ON SITE SEWAGE DISPOSAL SYSTEM DESIGN PLAN
HYMAN PROPERTY
 L. 19049 F.233
 FOLLY QUARTER ROAD
 PARCEL 140

From: Ron Thompson <ron@vanmar.com>
Sent: Wednesday, March 2, 2022 12:37 PM
To: Wolf, Kevin
Cc: Wt Coon; Shorty (wtccoon@aol.com)
Subject: Foxleigh/Hyman Property Parcel 140
Attachments: doc_20220302121916.pdf

REVISIONS: DELETE TANK ANCHORING

ON SITE SEWAGE DISPOSAL SYSTEM DESIGN PLAN

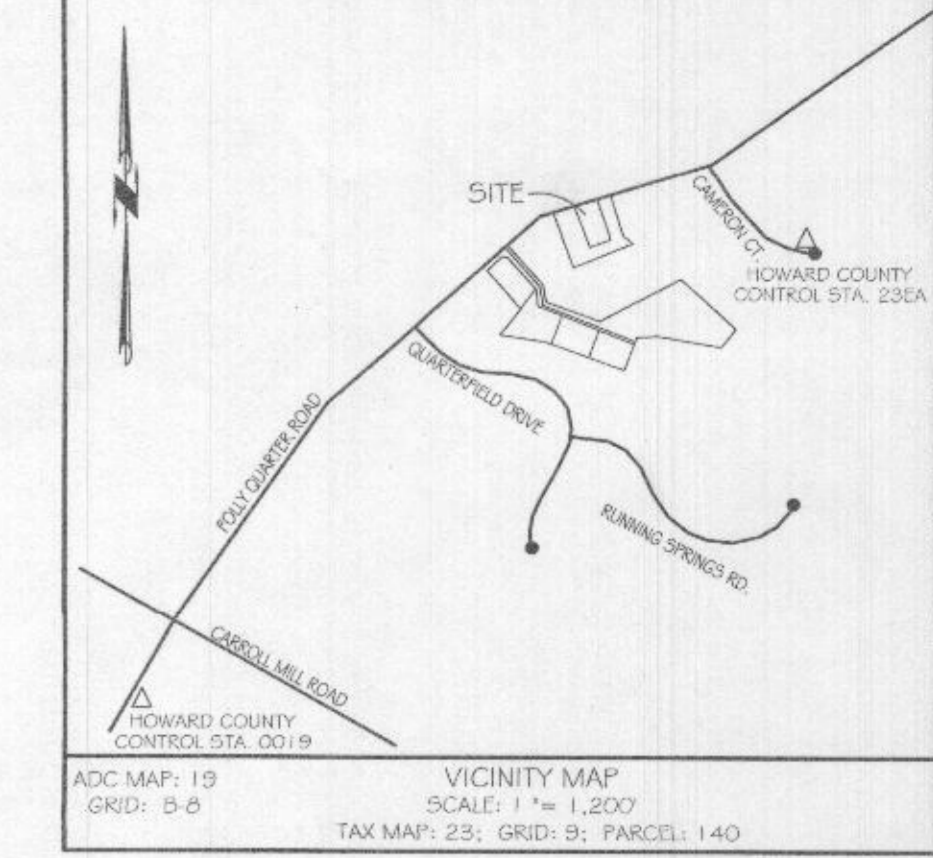
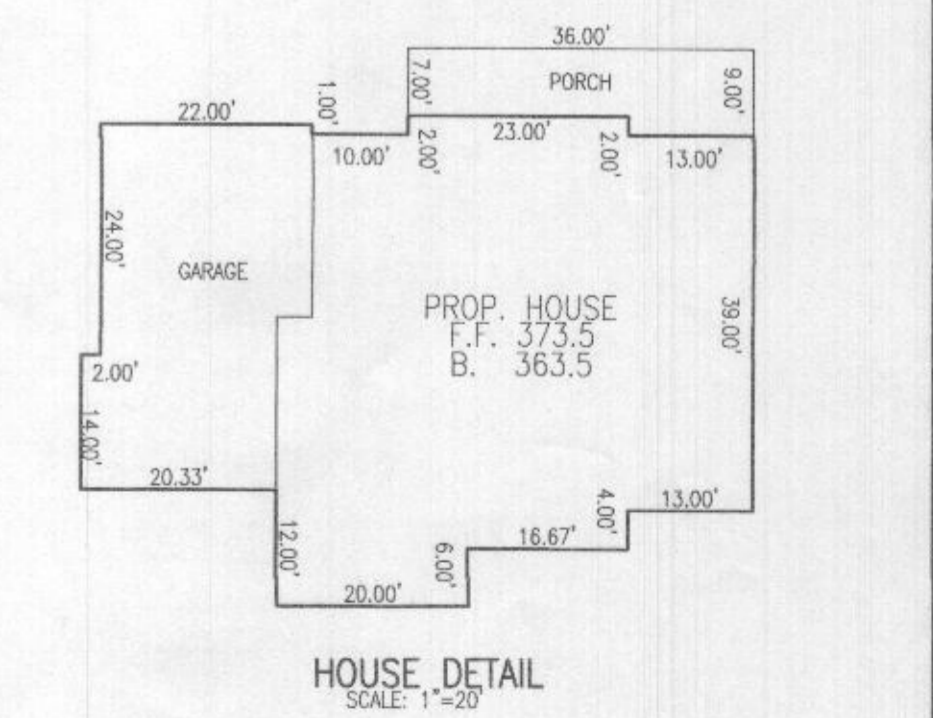
When the design was originally completed, the anti-flotation device was requested by the Health Department. We did not complete any anti-flotation computations at that time. I have now completed the Ant-Flotation Computations for the 2000 gallon septic tank and the 1500 gallon pump tank being used on Parcel 140. Based on the weight of the septic and pump tank (as provided by manufacturer), both structures do not require any anti-flotation measures such as strapping or additional concrete weight. These computations are attached.

Factor of Safety = 1.93 > 1.2 OK

Factor of Safety = 1.98 > 1.2 OK

ON SITE SEWAGE DISPOSAL SYSTEM DESIGN PLAN
HYMAN PROPERTY
L. 19049 F.233
FOLLY QUARTER ROAD
PARCEL 140

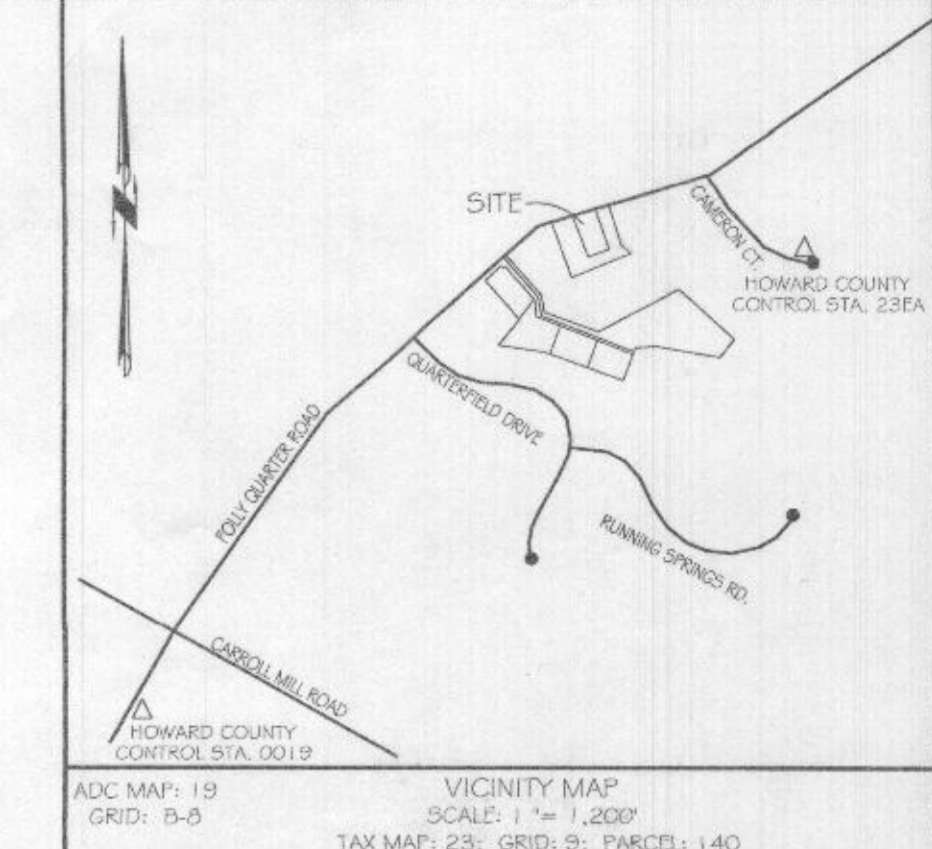
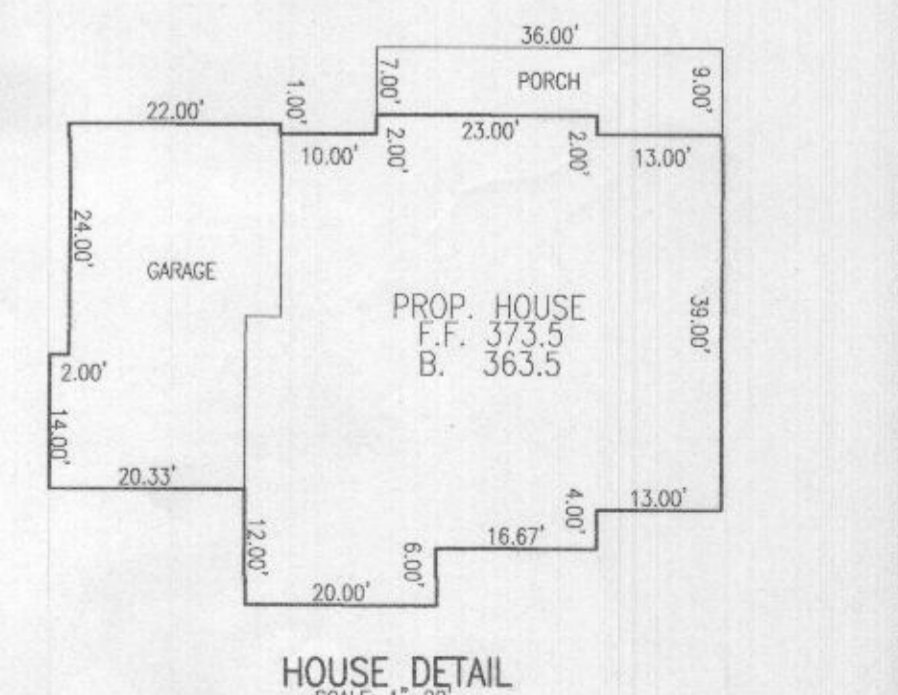
DATE: 03/03/22
REVISIONS: DELETE TANK ANCHORING
